ADDENDUM NUMBER 2

| NOTIFICATION DATE: | BID TITLE: | BID NUMBER: | BID OPENING DATE & TIME: |
|-----------------------|---|---------------|----------------------------|
| 01/23/14 | Port Royal Pump Station Improvements | 14-015 | 02/04/14 2:00PM |

| DRAWING S-102 |

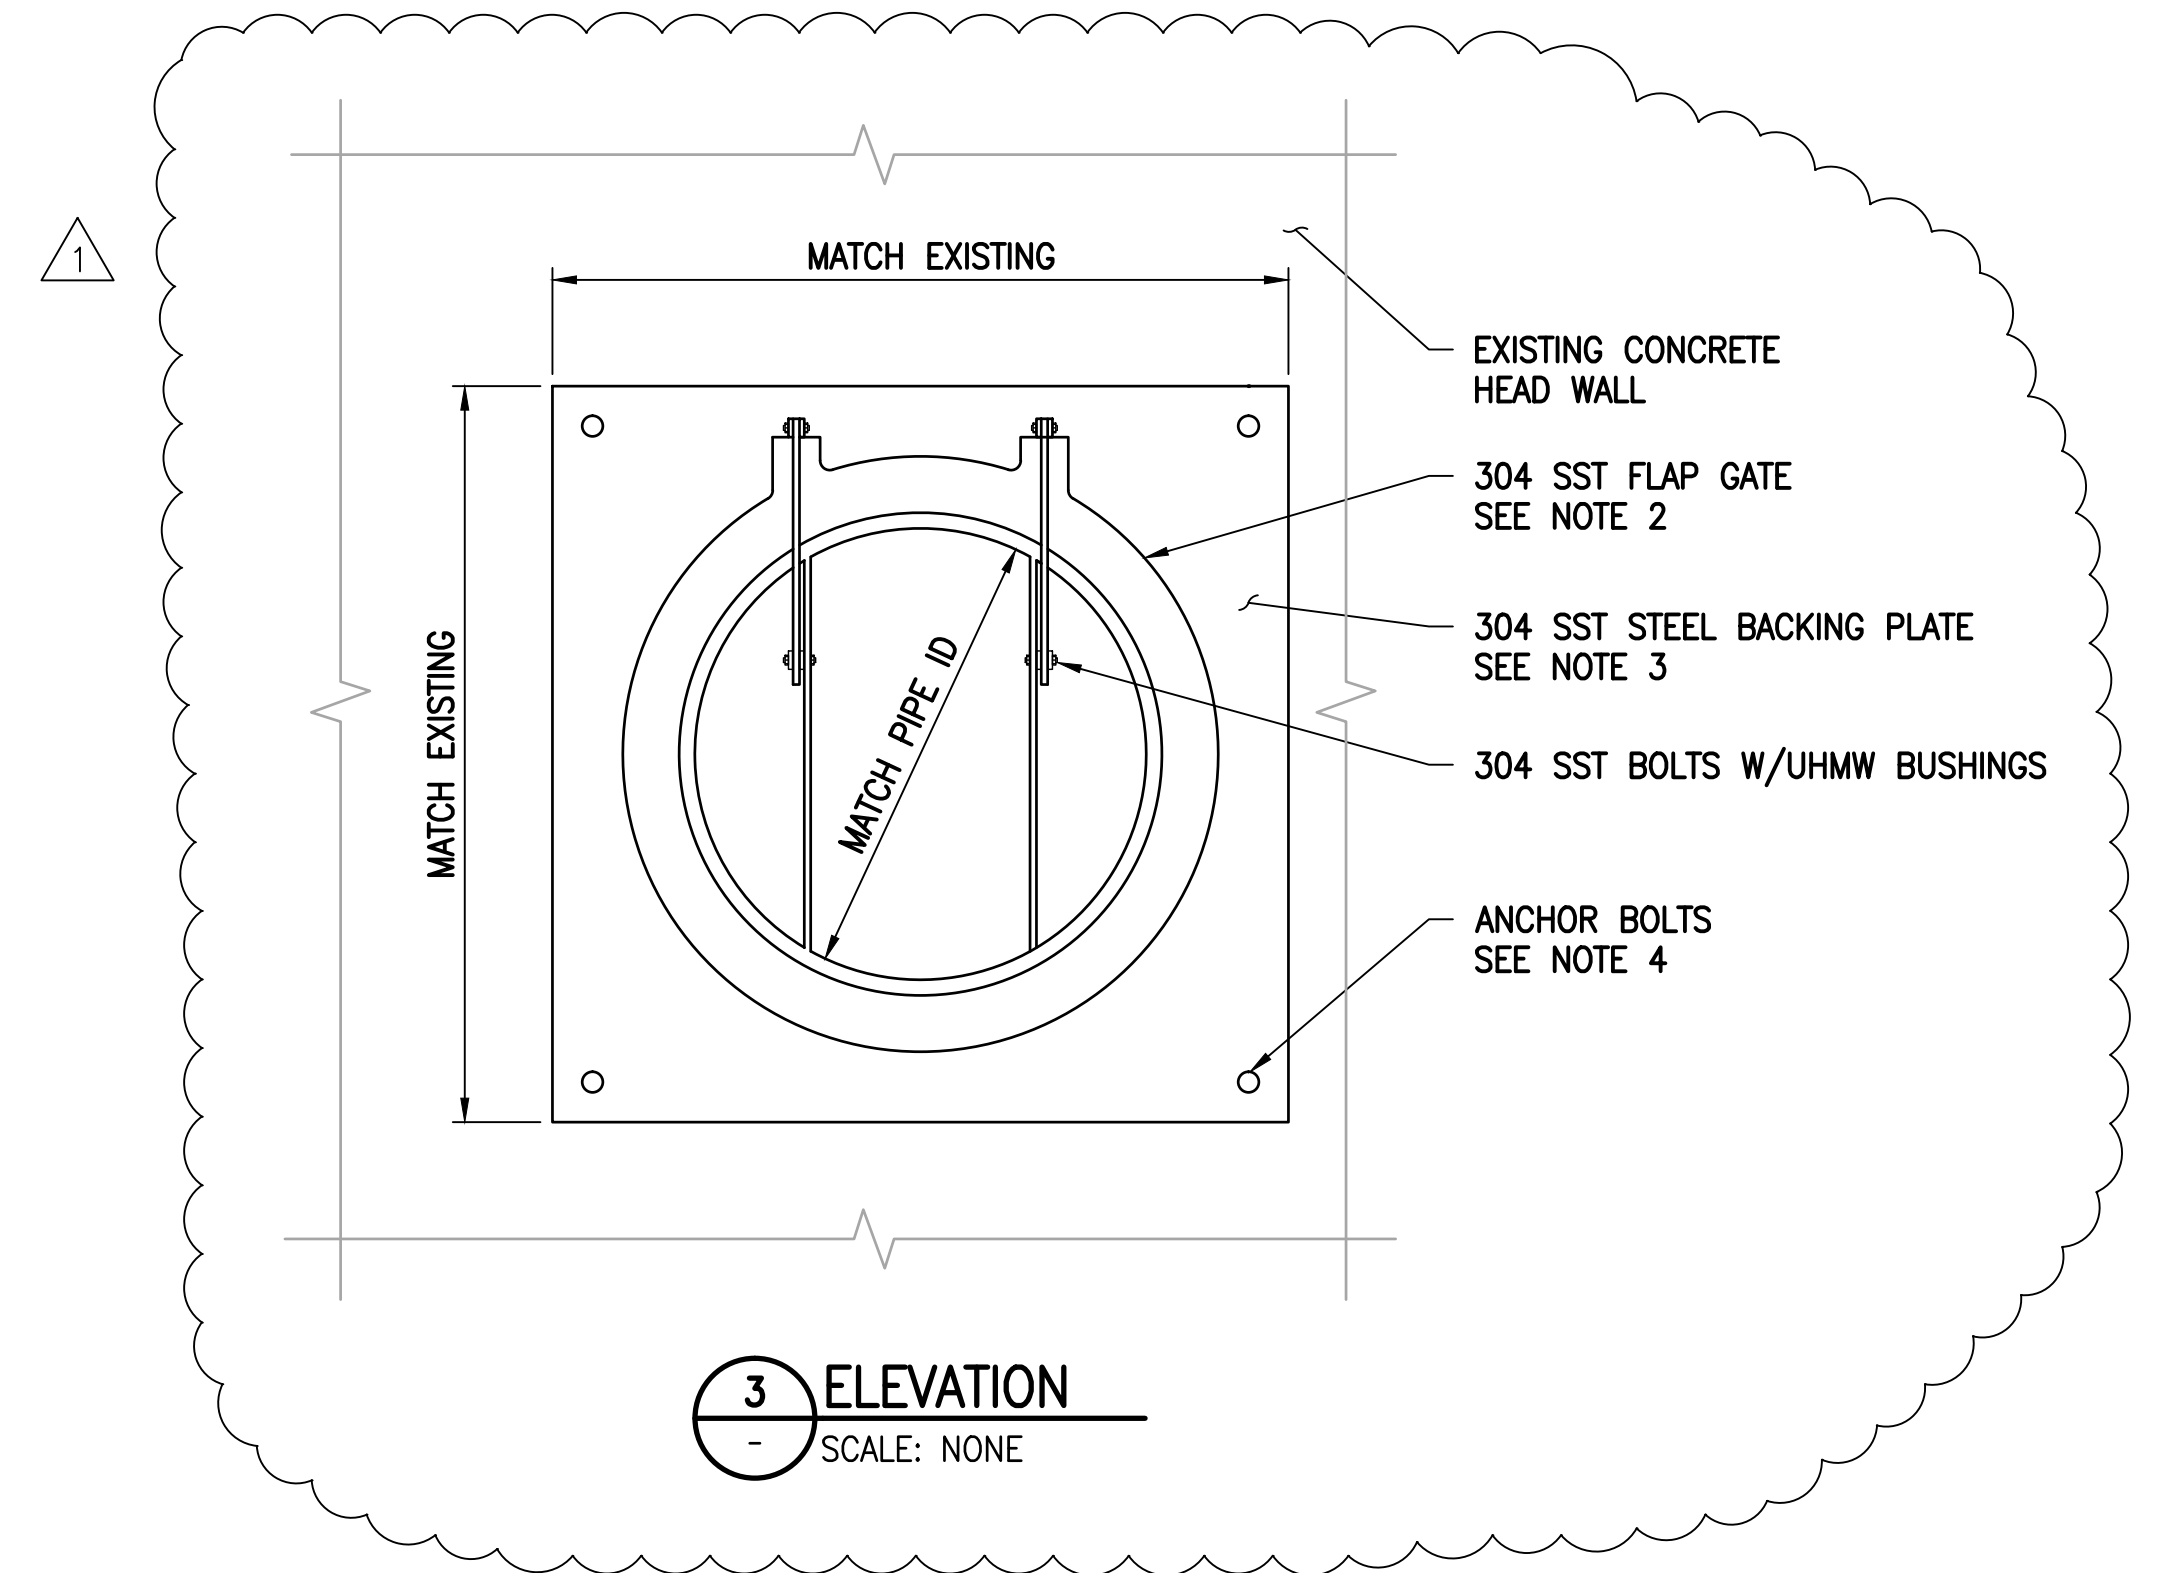
- **Note Drawing S-102 (Existing Outfall Structure) and Drawing C-102 (Existing Site Plan Pump Station Outfall) as Attachments**

11. Is there any concrete restoration associated with flap gate swap?
Answer: Yes, see Note No.6 on drawing S-102.

24. Does the concrete restoration located at the flap gate require the work area to be dry?

Answer: No, Refer to revised drawing S-102, the repairs materials have been changed to allow for work in wet or underwater conditions.

| CITY OF NAPLES PORT ROYAL PUMP STATION | | DRAWING C-102 |

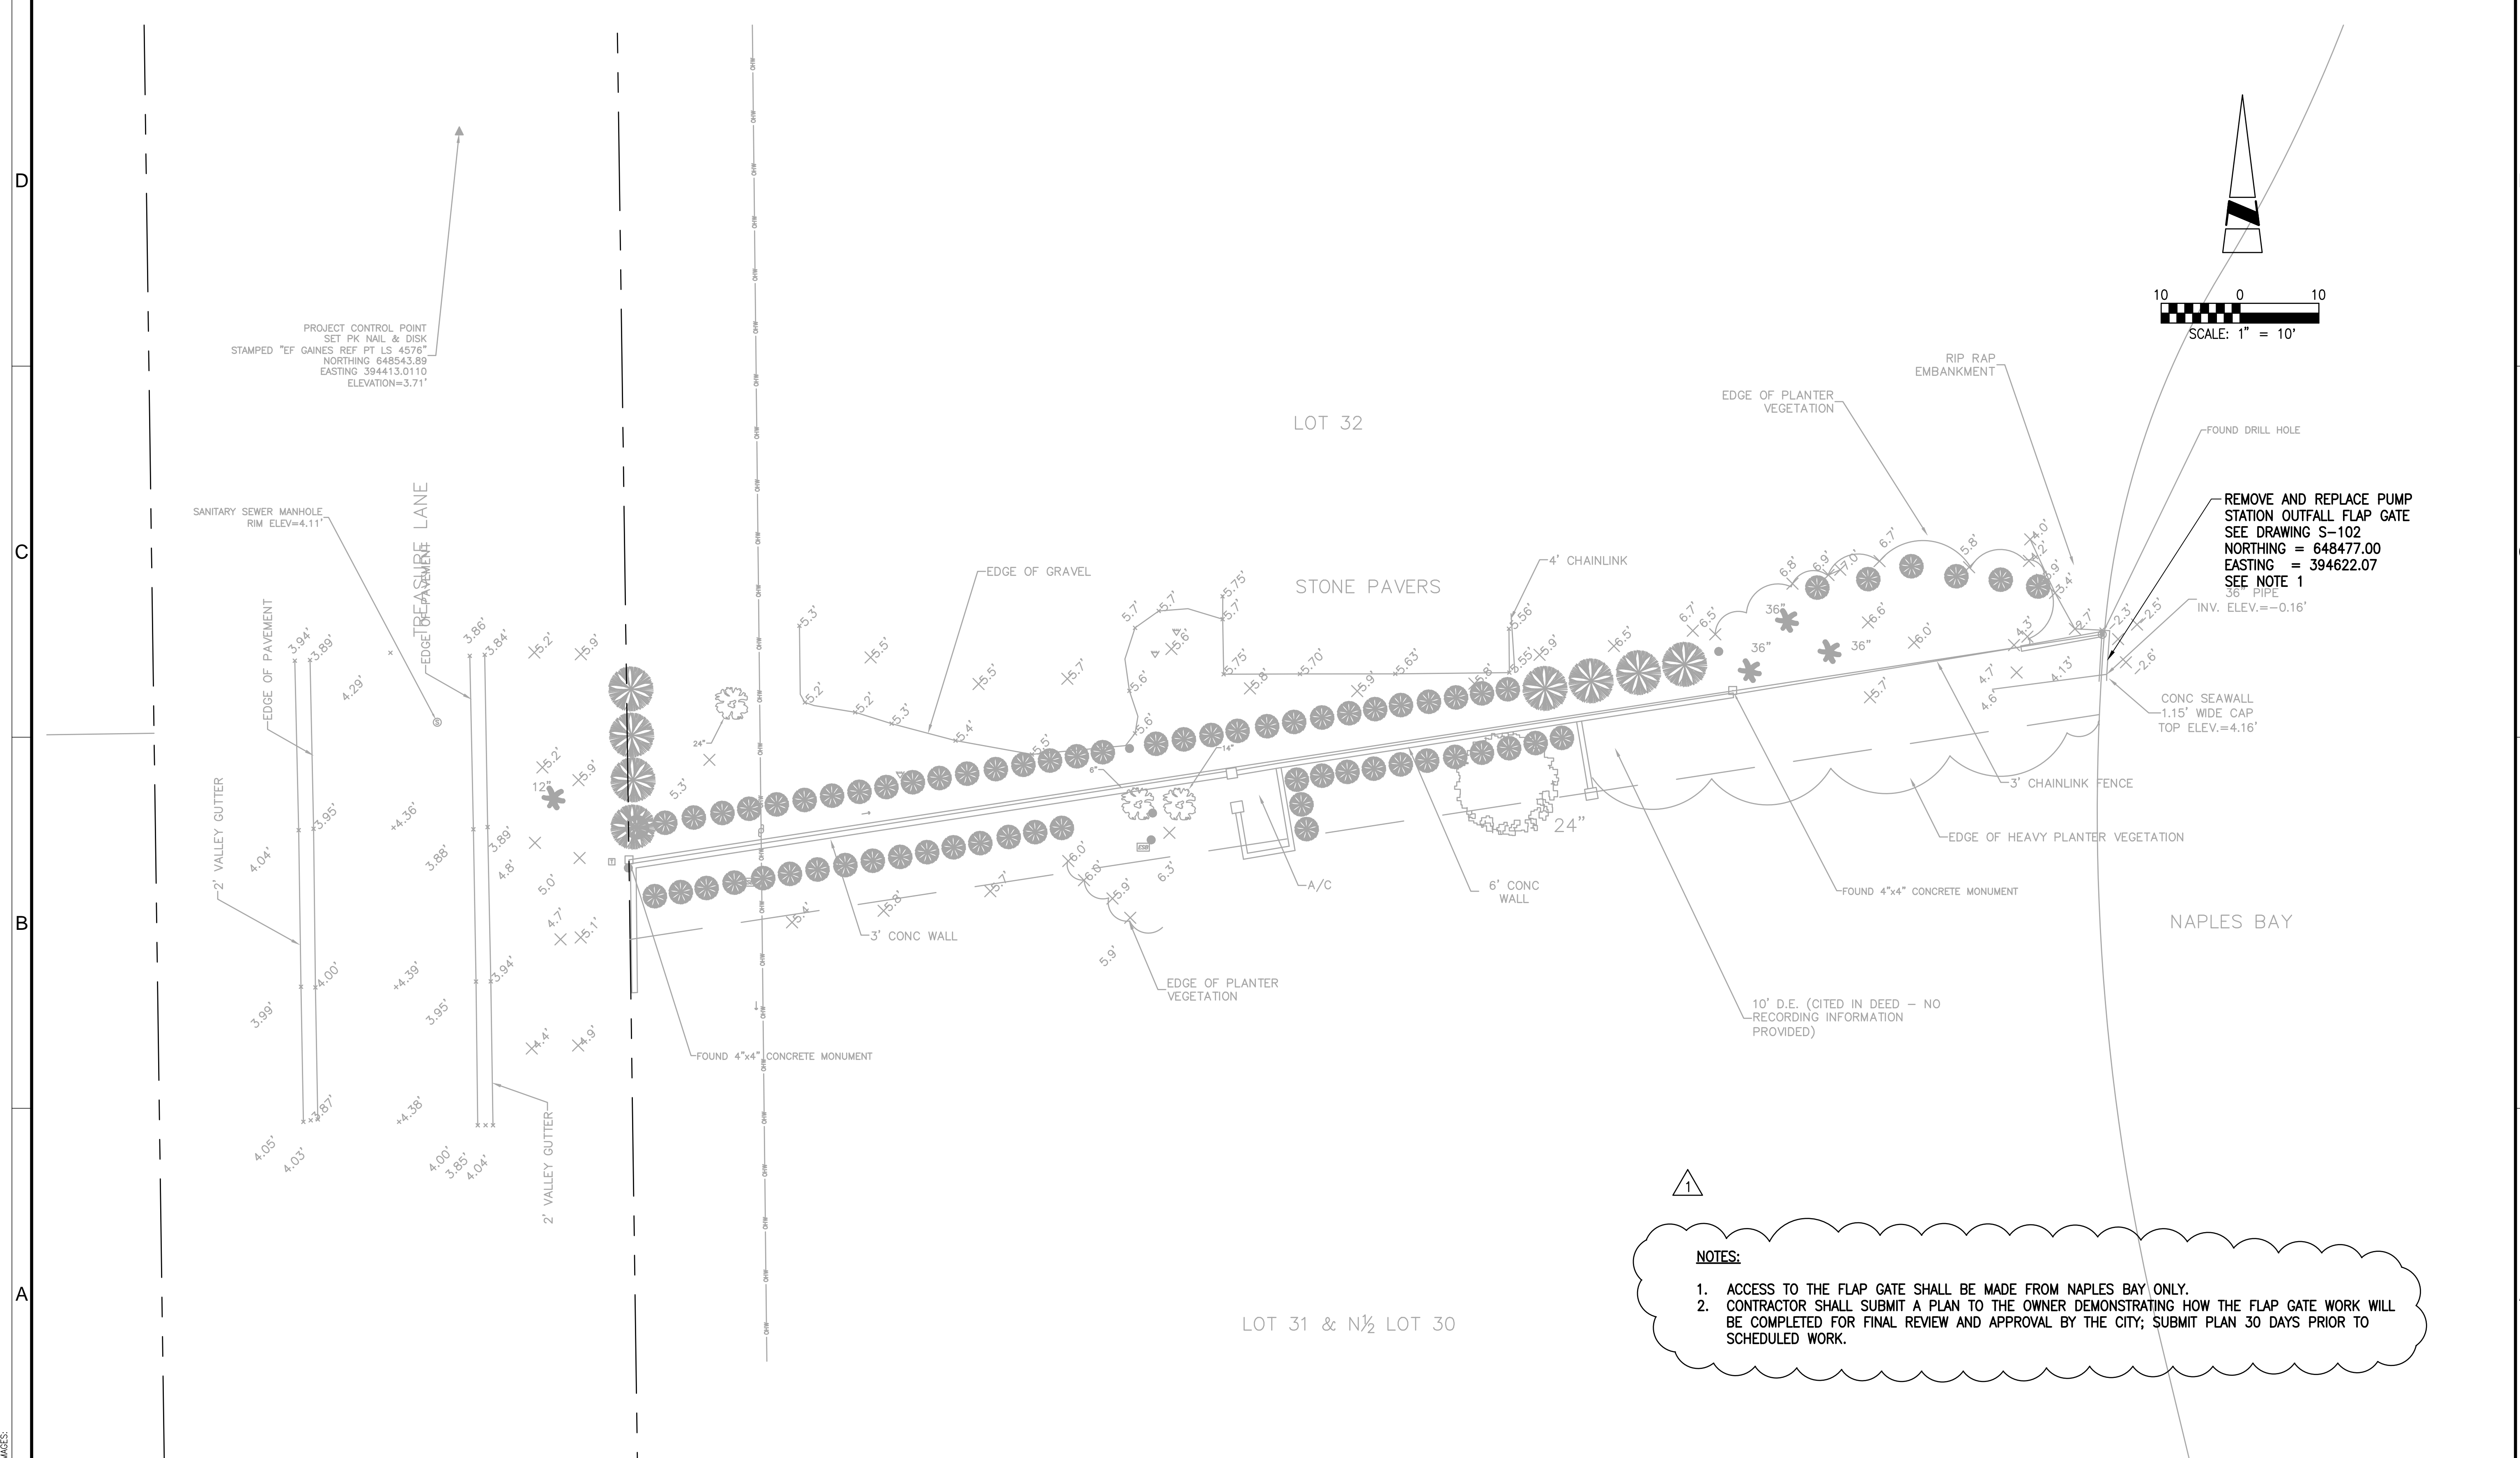
25. Can the flap gate be access from Naples Bay?

Answer: Due to the fact that access to the easement is difficult because of landscaping, fencing, traveling through private property, etc.; access to the outfall/flap gate is restricted to Naples Bay only, refer to revised drawing C-102.

- ACCESS TO THE FLAP GATE SHALL BE MADE FROM NAPLES BAY ONLY.
- CONTRACTOR SHALL SUBMIT A PLAN TO THE OWNER DEMONSTRATING HOW THE FLAP GATE WORK WILL BE COMPLETED FOR FINAL REVIEW AND APPROVAL BY THE CITY; SUBMIT PLAN 30 DAYS PRIOR TO SCHEDULED WORK.
